ADDENDUM NO. 1

DATED February 10, 2026

RJE Renaissance Center Gymnasium Renovation Project – Phase III Starke, Florida

DEMOLITION FLOOR PLAN

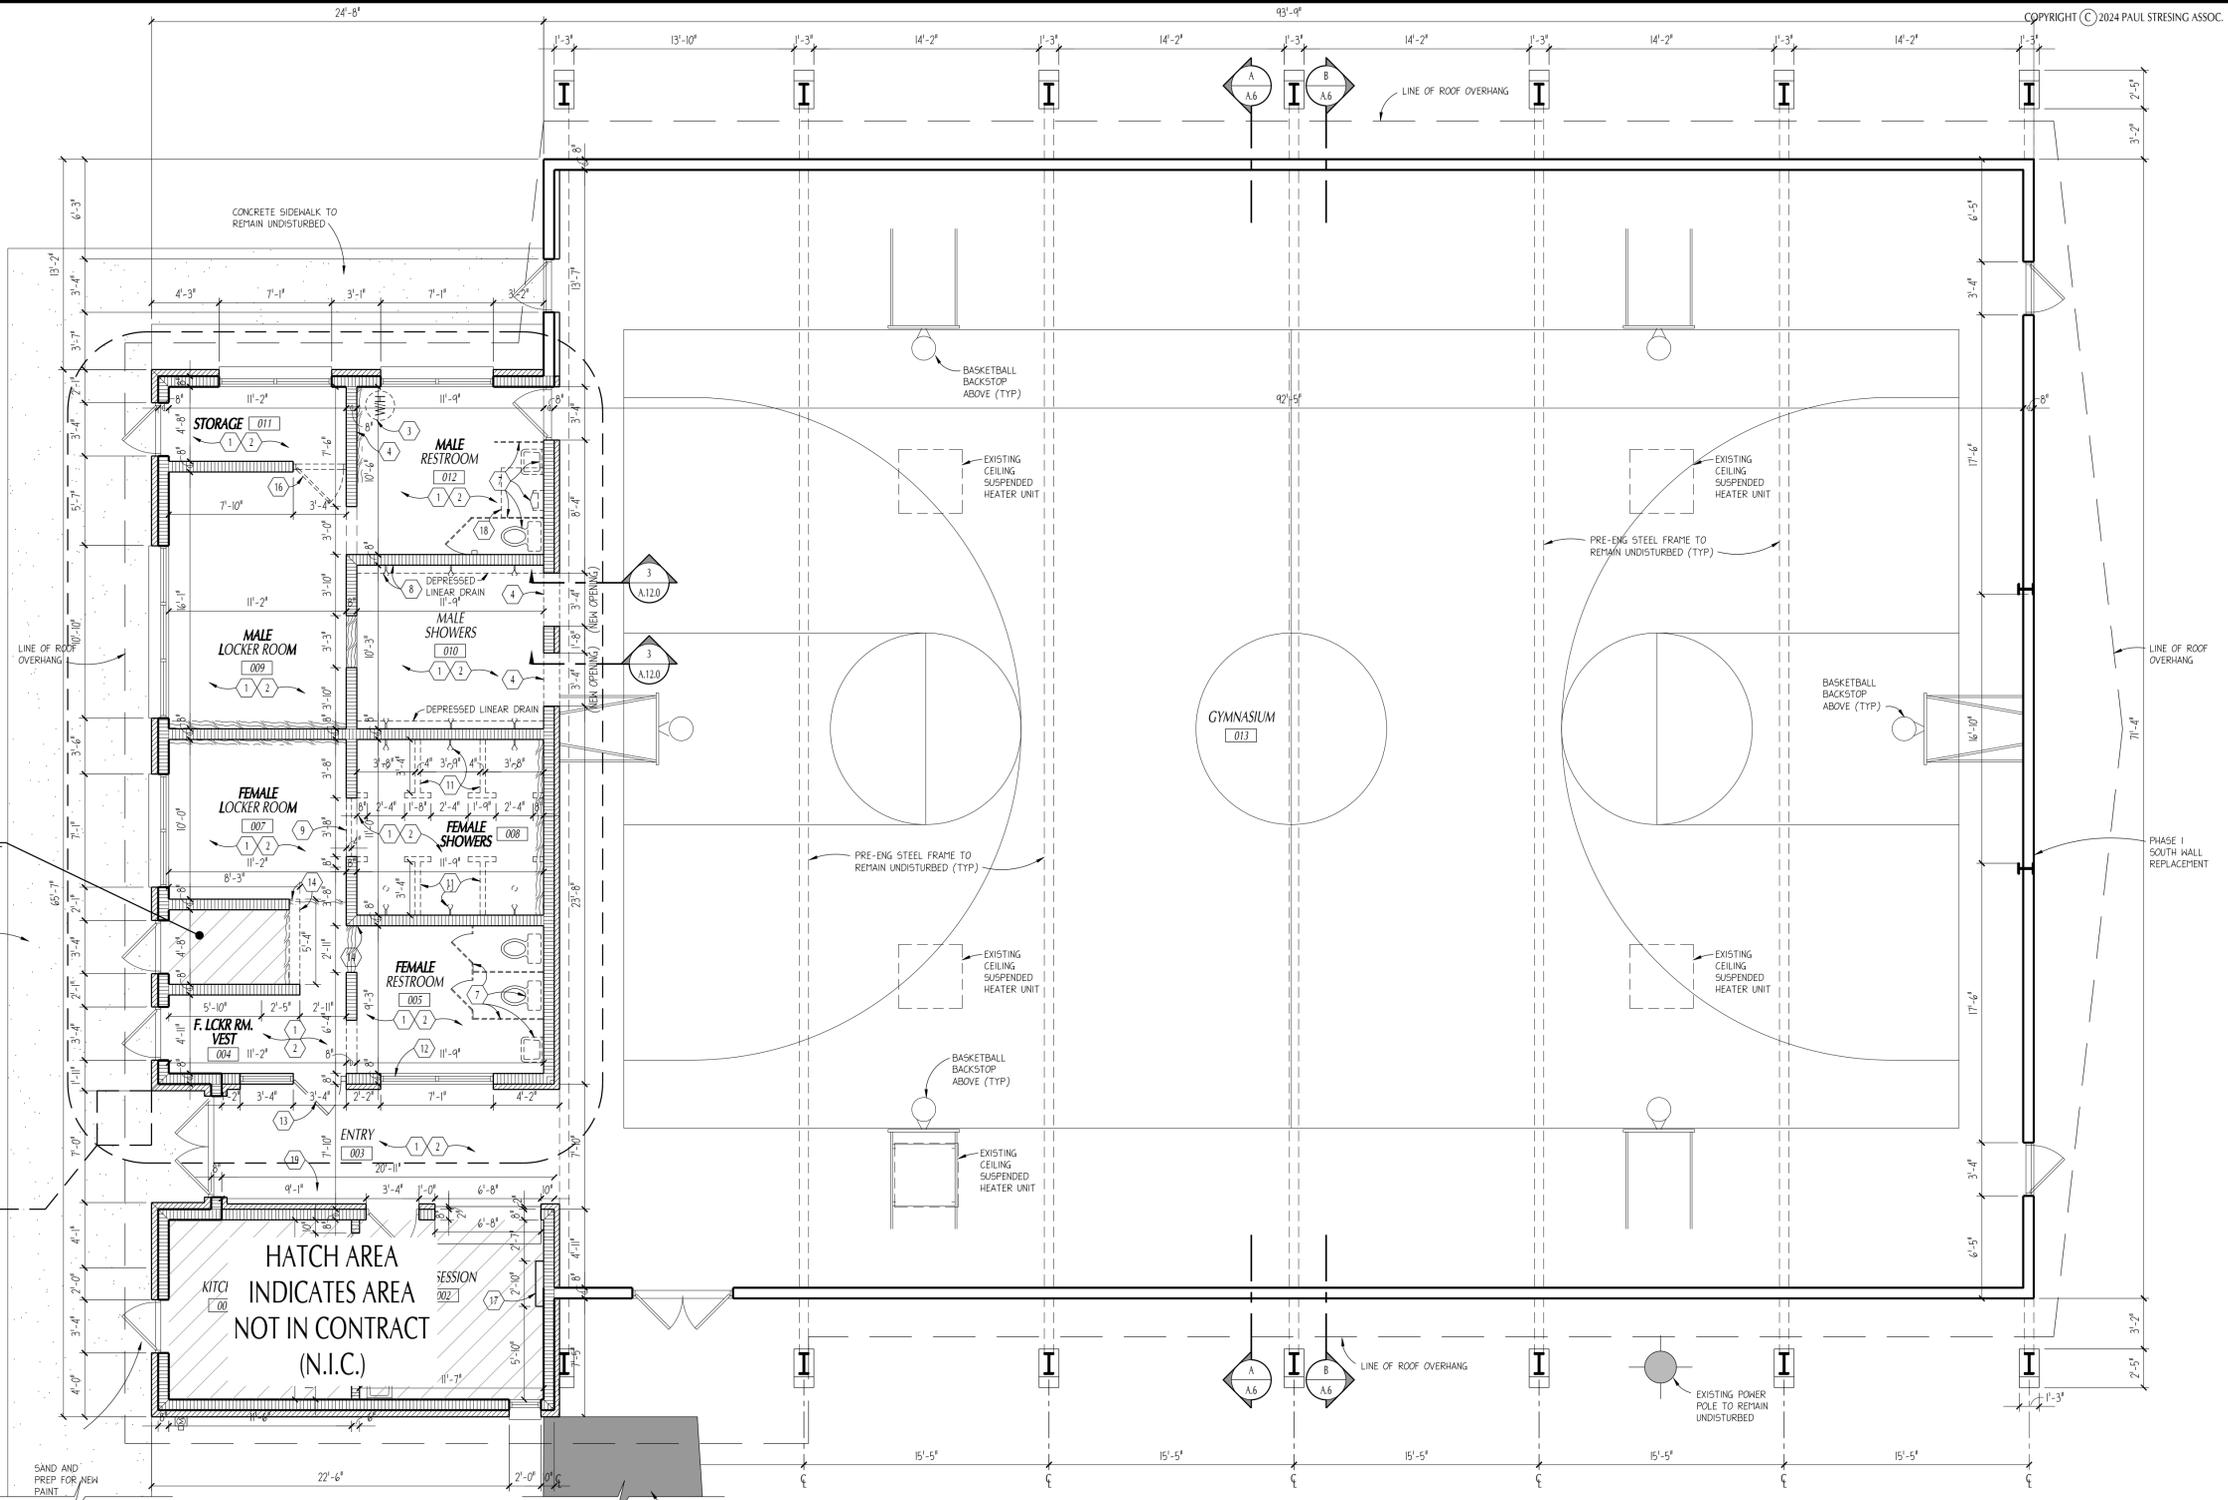
- 8. Drawing Sheet A.8 Demolition Floor Plan:**
- A. At Demolition Notes, delete reference to note #15, this door has been eliminated from the scope-of-work (see attached drawing sheet A.8).

- B. During transition of electronic files drawing sheet A.8 inadvertently cut off the bottom 1” of the sheet. Sheet A.8 has been adjusted to show all Demolition & General Notes (see attached drawing sheet A.8).

- C. At Demolition Notes #1 delete reference to “Removal of existing Sheetrock Ceiling and add in its place “Patch Existing Gyp Ceiling” (see attached drawing sheet A.8).
